FREDERICK COUNTY PLANNING COMMISSION

TITLE: Saint Paul Lutheran Church

FILE NUMBER: SP 14-01, AP# 14998, APFO# 14999, FRO# 15000

REQUEST: **Site Development Plan Approval**
The Applicant is requesting Site Development Plan approval a 2,764 s.f. addition to the existing church structure and an approximately 4,900 s.f. addition to the existing parish house for a new social hall (total: 5,880 s.f.) located on a combined 1.27-acre site.

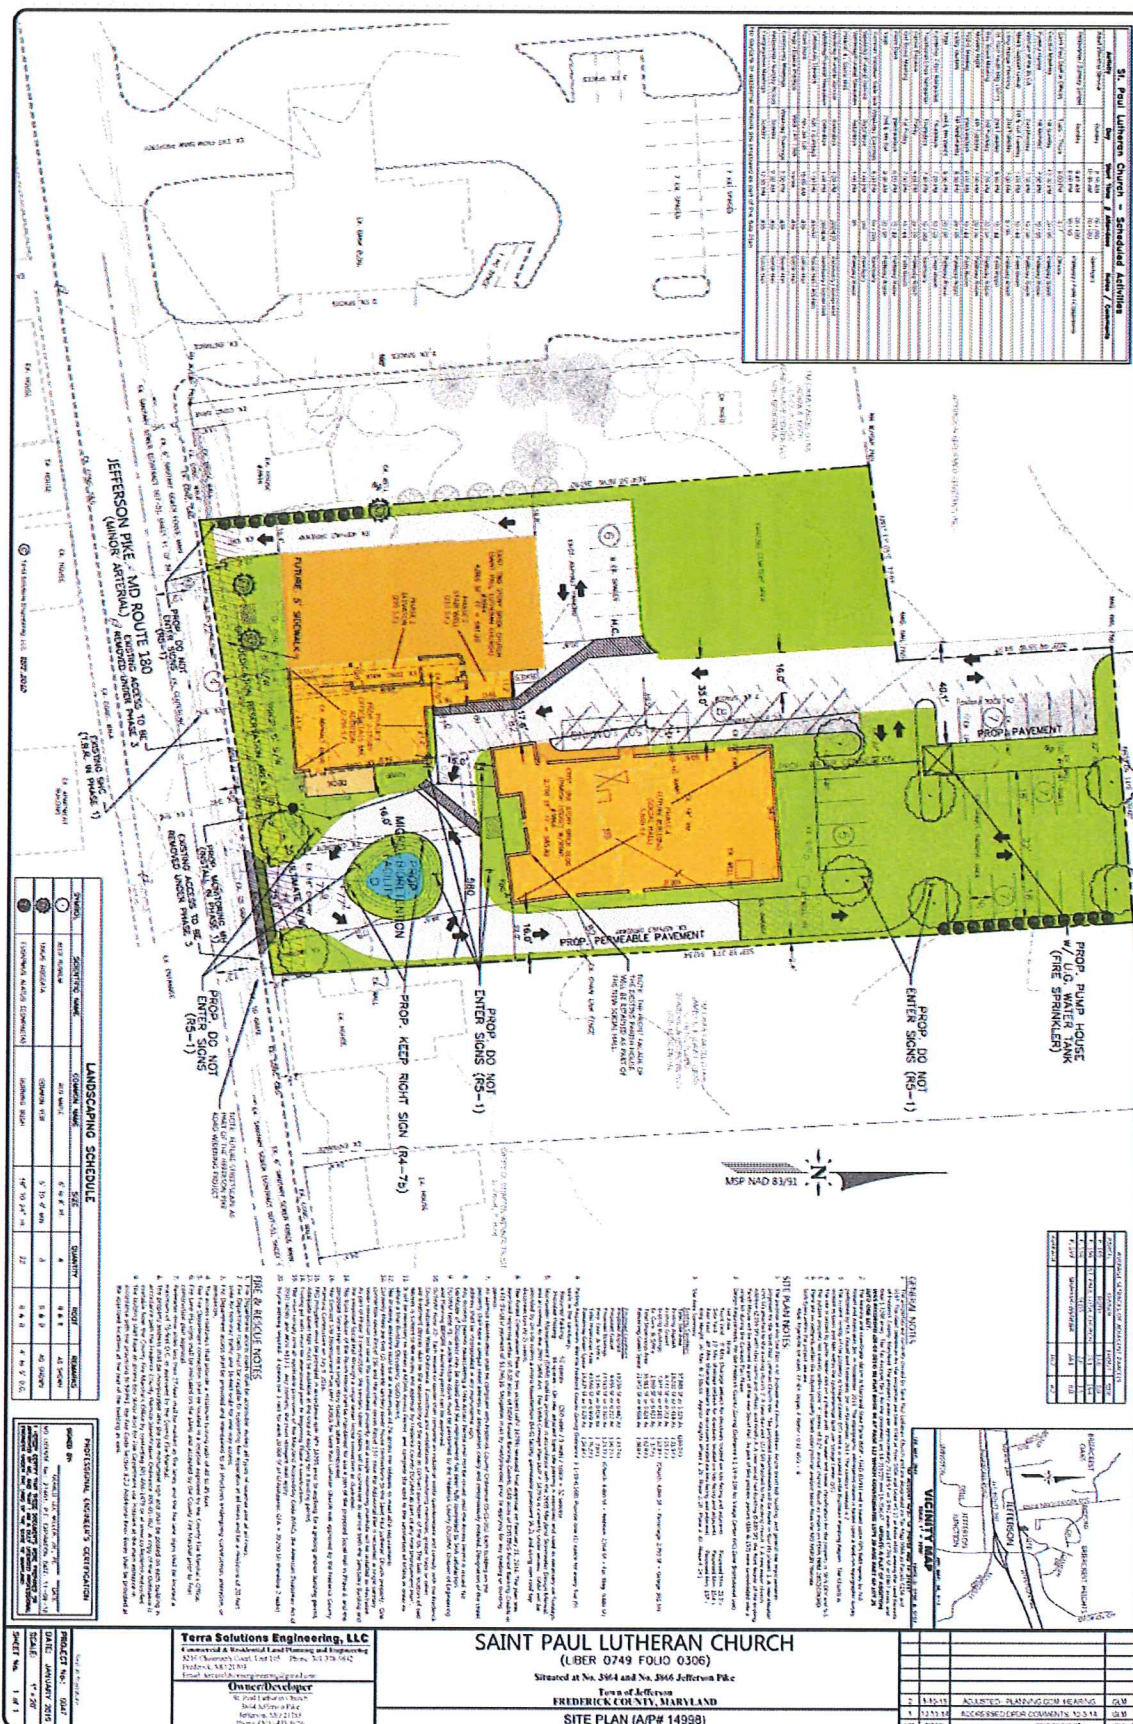
- 1) Applicant will work with Staff to finalize the preliminary design of the social hall and church sanctuary buildings to best protect the historic integrity of the structures and the Jefferson Survey (Historic) District.

- 3) Applicant shall refine the design of pedestrian paths/routes on the Site to allow pedestrians to move safely and easily between Jefferson Pike and the new social hall entrance.

- 4) Applicant shall label the proposed large loading area on the eastern side of the social hall.
- 5) Applicant must include a note on the plan acknowledging compliance with the Frederick County Bicycle Parking Design Guide and label the bicycle parking area appropriately.

- 6) Approval of the modification to allow two street trees to be planted along the property frontage and to approve the alternate planting design proposed by the Applicant and as amended by Staff to require the planting of additional screening shrubs adjacent to the parking area located at the rear of the church sanctuary.

Phase 3: Annex Addition

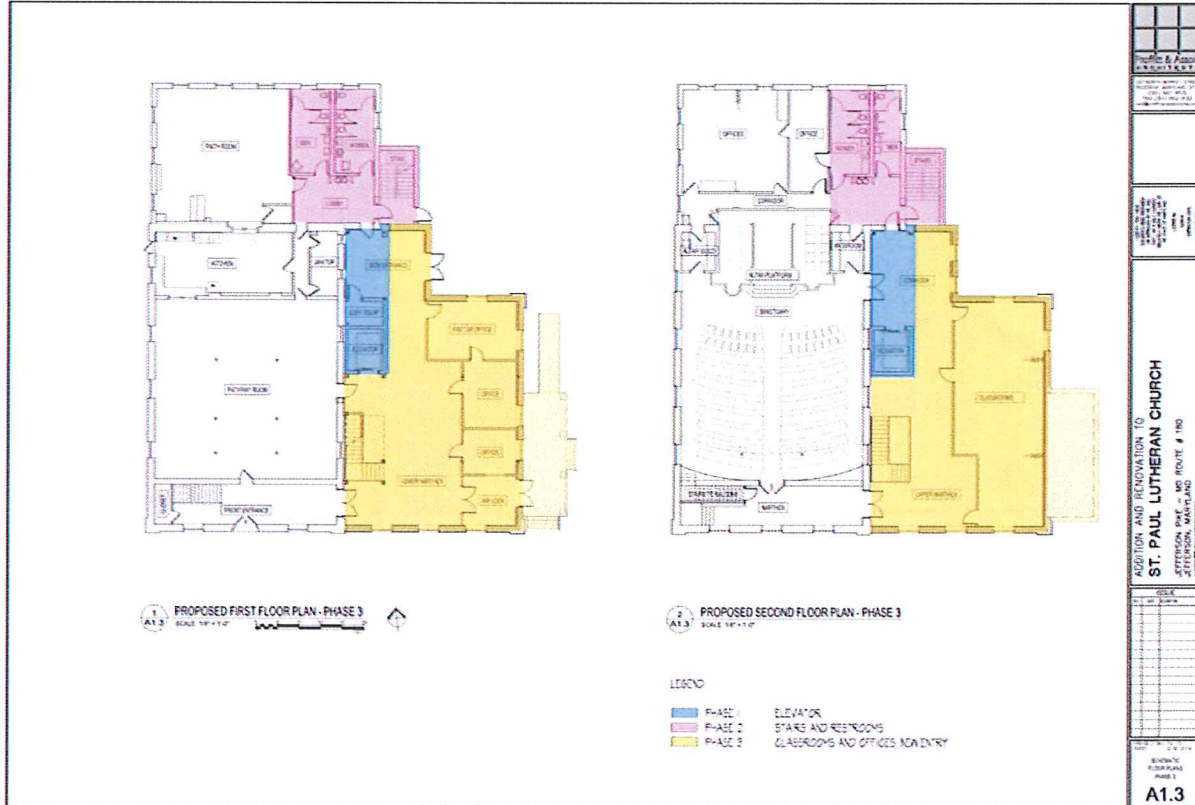
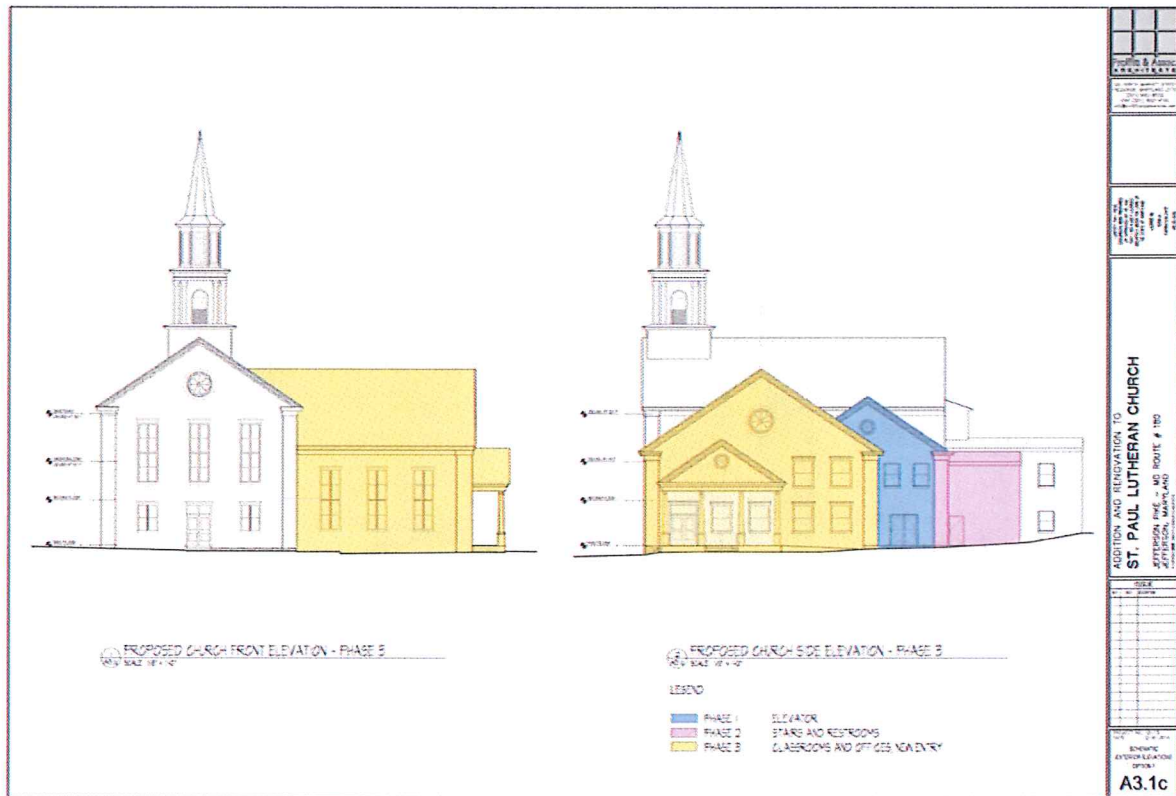
C.4.(a)/C.4.(b) – Form/Height: With no community or corridor plan in effect for the Jefferson community building massing and bulk is limited only by the underlying zoning regulations. The expansion of the sanctuary building will continue its visual dominance of the Site as viewed from the street. However, the newly configured vehicular drive - and the redevelopment and expansion of the parish house into a larger social hall -will place a greater emphasis on this secondary structure. Maintaining the front portion of the historic parish house will allow the church sanctuary to retain its preeminent position as the most important building on the Site. The placement of the new social hall toward the center and rear of the Site also allows the current streetscape of Jefferson Pike to retain this small pocket of space which serve to accentuate the form of the historic church building.

C.4.(f) – Building Design: The visualization material submitted for the Site Development Plan generally provides adequate information related to building shape, height, massing and window and door placement. Staff has been working with the Applicant to ensure building design and finishes that are internally cohesive and respectful of the historic structures on the Site. All of the buildings in this project are oriented to show their access/entry features to the public or private internal drive or court. The concept plan maintains human-scaled architectural elements as illustrated in the conceptual architectural elevations for the renovations. Although specifics regarding materials and finishes remain those reviewed at the time of Concept Site Plan review, the visualization material submitted for that application generally provides information related to building shape, height, massing and window and door placement. The Applicant has recently submitted elevations and a limited rendering of the expanded sanctuary structure itself to reflect design changes that have evolved since the approval of the Concept Plan.
